CURVED RAILING ALONG DRIVE

PROPOSED REVISION – OPTION 1

Original Railing – Along Drive

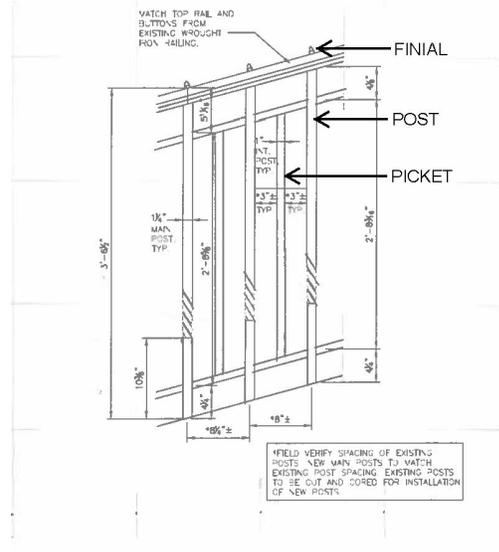
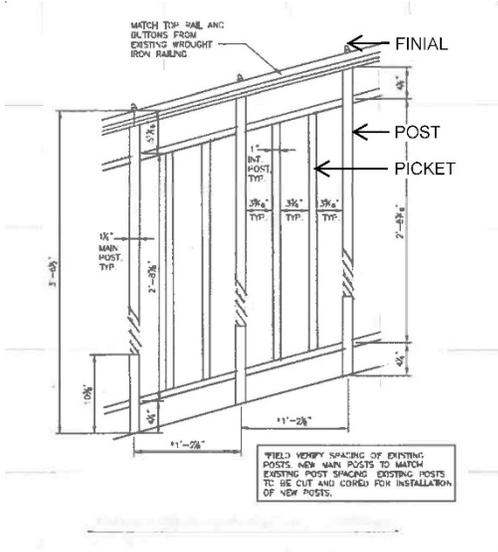
Discussion that post spacing to match holes of existing post spacing (no new holes to be drilled in granite)
Post spacing on progress drawings shown as 14"
Actual post spacing is roughly 8-1/2" on center

Per 01/2025 meeting, post spacing revised to 8-1/2"
As a result, Bid Documents were shown as follows:

CONSTRUCTION BID DOCUMENTS

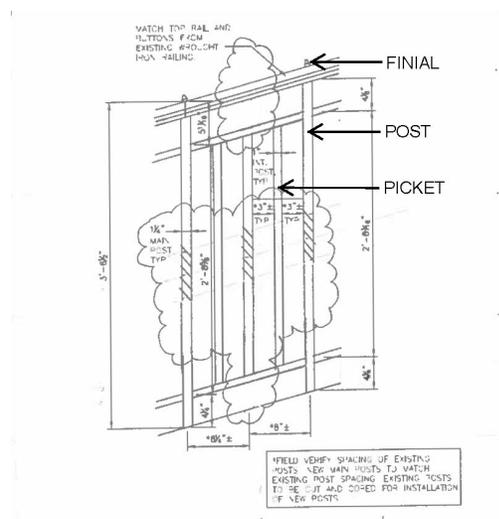
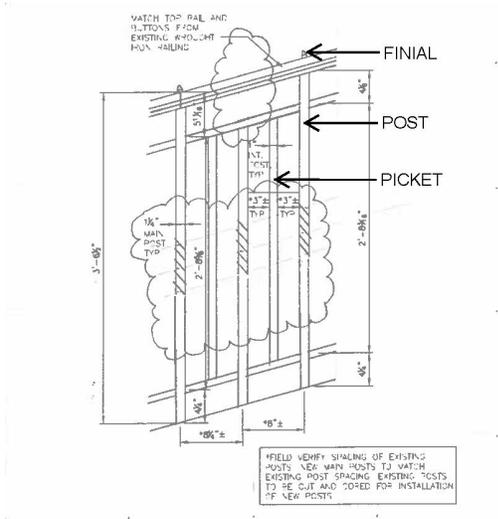
- One picket between posts, not two pickets
- Finials at 8-1/2" and not 17" as in original railing
- Horizontal space below top rail extends 8-1/2" and not 17" as in original railing
